## MEMORANDUM

**RE: CEQA Compliance for Requested Revision to Approved MacArthur Station<sup>1</sup> Parcel A and Parcel C-1 FDPs**

**MACARTHUR STATION BLOCKS A & C1**  
 40TH AND TELEGRAPH OAKLAND, CA

**Proposed Changes to Site Plan from Parcel A FDP**

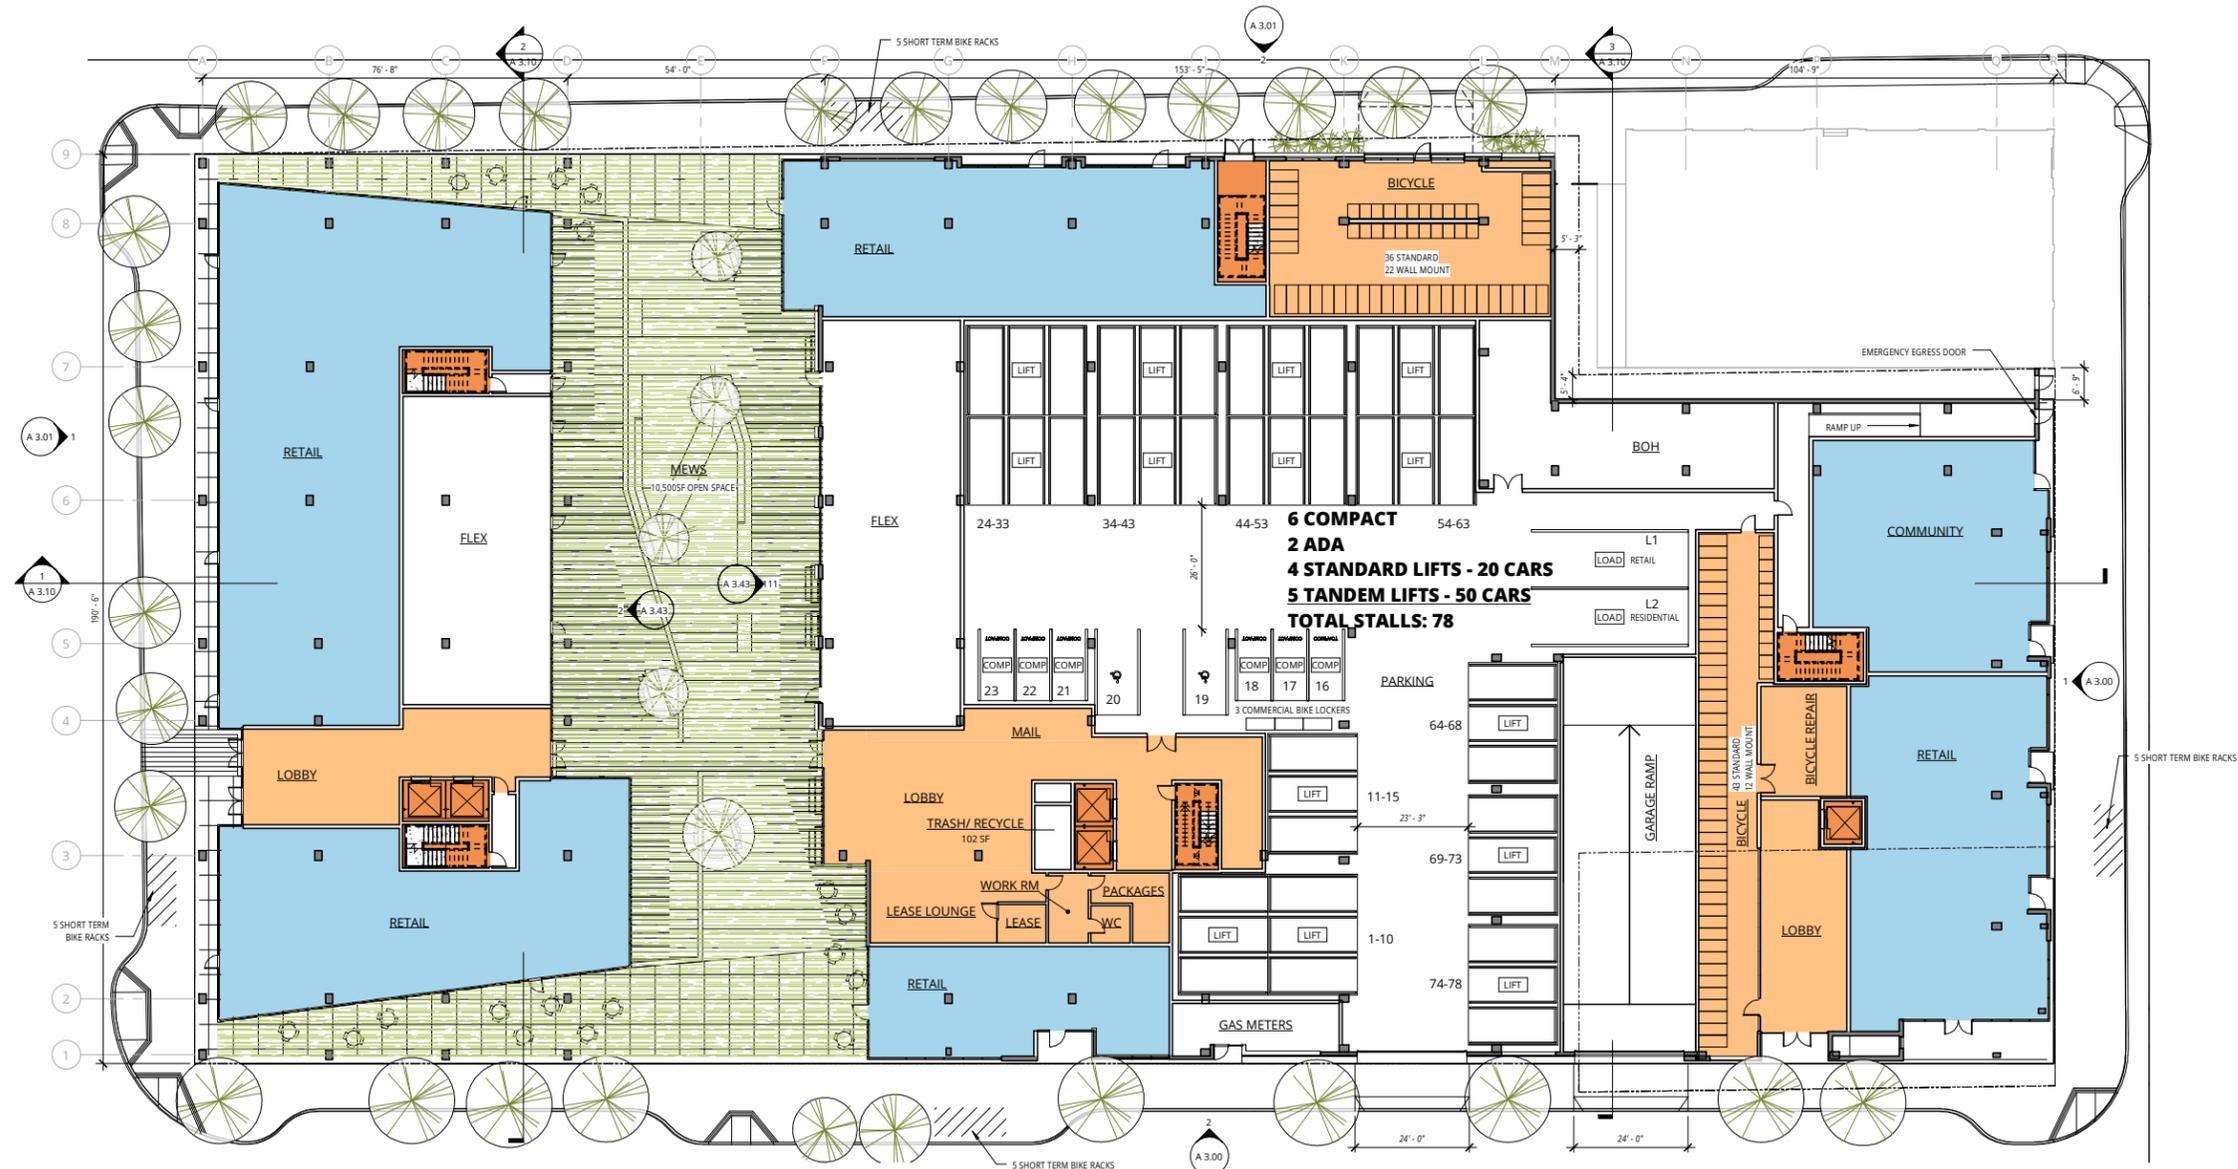
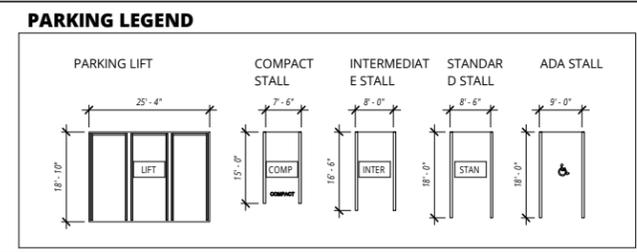
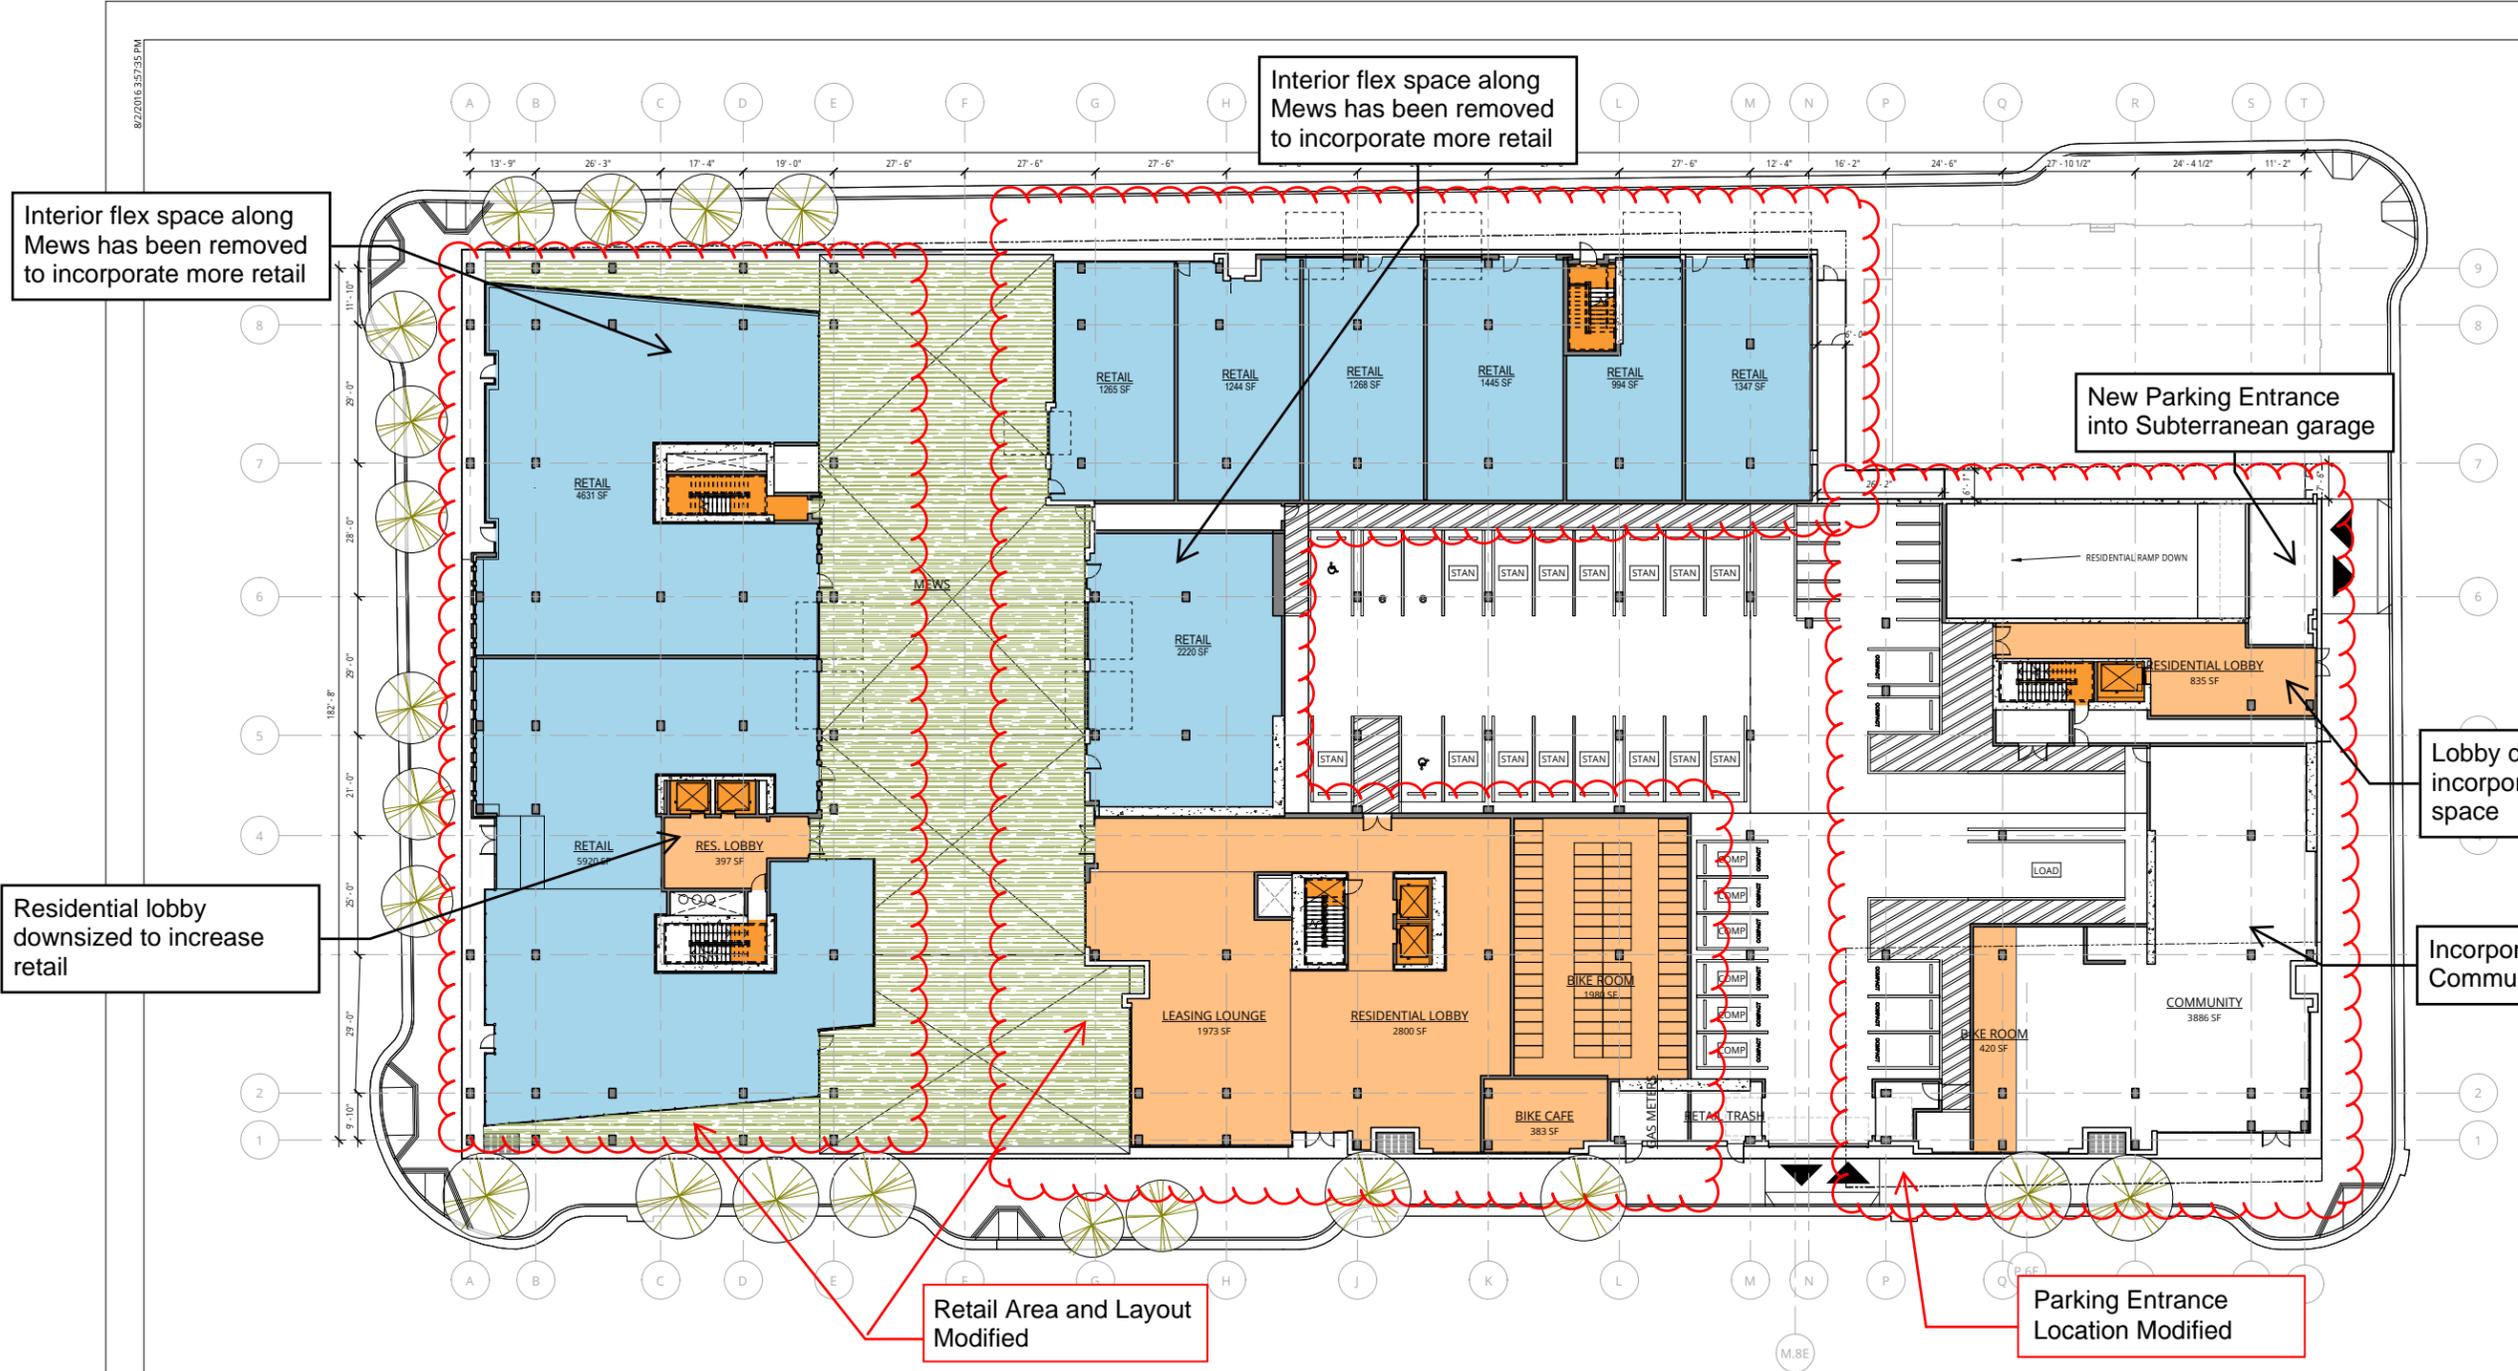
Buildings A1 and A2 and the residential lobby in Building A1 has been downsized to incorporate additional retail. Additionally, along the northern portion of Building A2, the bicycle storage area has been converted to retail space. Bicycle parking has been relocated to the southern portion of Building A2, where the residential lobby and leasing space has also been adjusted, and community space has been incorporated at the corner of 39<sup>th</sup> Street and Telegraph Avenue.

The revision application proposes that, should the developer not be able to lease the space to retail tenants within a certain timeframe, the retail space along 40<sup>th</sup> Street be converted to live/work units. The developer would market the approximately 4,631 square feet of convertible retail space in Building A1 and the approximately 7,563 square feet of convertible retail space along 40<sup>th</sup> Street in Building A2—totaling 12,194 square feet—as retail space during the period starting on the commencement of construction and ending nine (9) months after the completion of construction for the applicable building. This is currently anticipated to be thirty-three (33) months of active leasing. In the event developer is unable to lease all or any portion of such convertible retail space to suitable retail tenants on commercially reasonable terms during the described leasing period, the unleased space could be converted to live/work units.

In addition, the applicant proposes to market the approximately 2,200 square feet of convertible retail space located in the interior of Building A2 along the mews as retail space for a period of eighteen (18) months, starting with the commencement of construction of Building A2. In the event that the developer is unable to lease all or any portion of such space to suitable retail tenants on commercially reasonable terms during the initial 18 months of construction, the unleased space would be converted to live/work units or resident-serving amenity space. If all of the above-described retail space—a total of 14,394 square feet—were not leased and were converted, this would represent an approximately 65 percent reduction in the amount of retail approved in the Parcel A/Stage 3 FDP. The converted space could result in approximately seven live/work units.

In addition to adjustments to retail space provision and use for Parcel A/Phase 3, driveway locations have been modified. Vehicular entry to the ground level parking garage on Parcel A would be from 39<sup>th</sup> Street and from Telegraph Avenue. This driveway would be located toward the center of the south side of the Building A2, on the north side of 39<sup>th</sup> Street, and has moved slightly eastward from its location in the Parcel A/Stage 3 FDP. The second driveway, located adjacent to the first driveway on 39<sup>th</sup> Street in the Parcel A/Stage 3 FDP, would now be located on Telegraph Avenue. This driveway would lead to the underground parking garage.<sup>4</sup>
